9/9/2014

**Follow up questions from August 18<sup>th</sup> Cayuga meeting – City responses in BLUE.**

# Arrowhead Park - Naperville

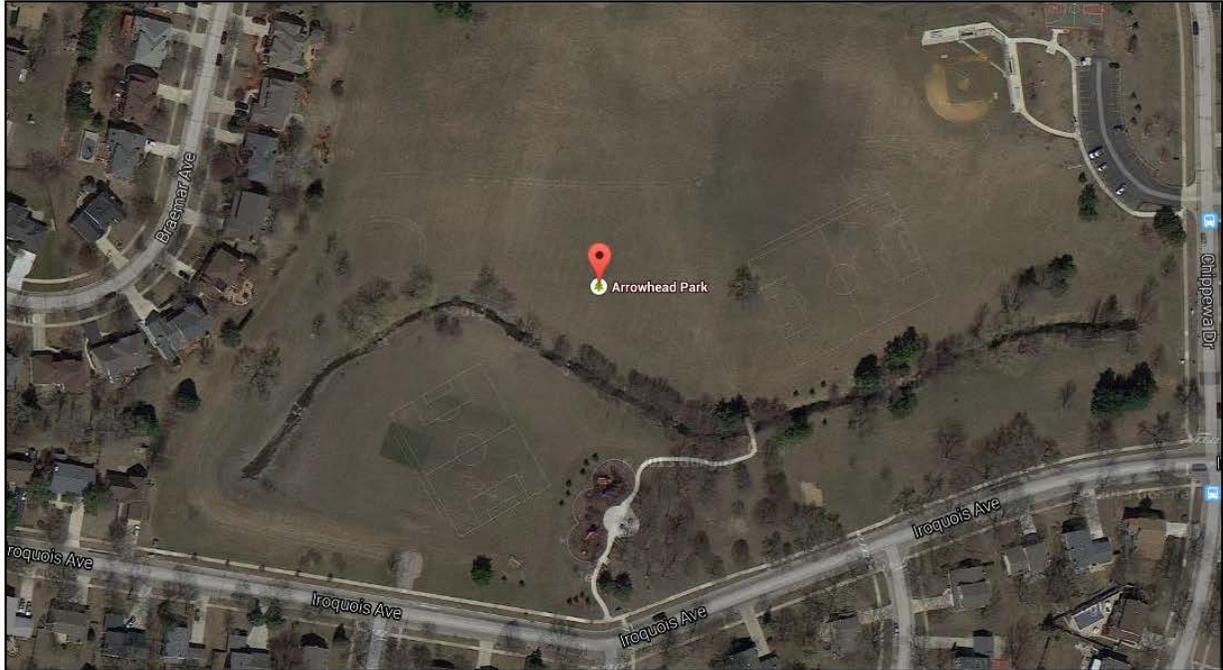
12. It would also be helpful to see photographs of other existing detention basins, with similar slopes, terracing and/or erosion control measures comparable to what is being proposed here.

13. Similarly, as requested in the public forum, it would greatly help to see drawings and photographs of comparable detention facilities that have been built in such close proximity to homes and playgrounds.

Four examples of dual-purpose (park and storm water detention) facilities are attached. They include Arrowhead Park, Eagle Park, and Three Meadows Park in Naperville and Pottawatomie Park in Tinley Park.

See response to #12. All of these facilities are adjacent to homes and include playgrounds and/or playing fields.
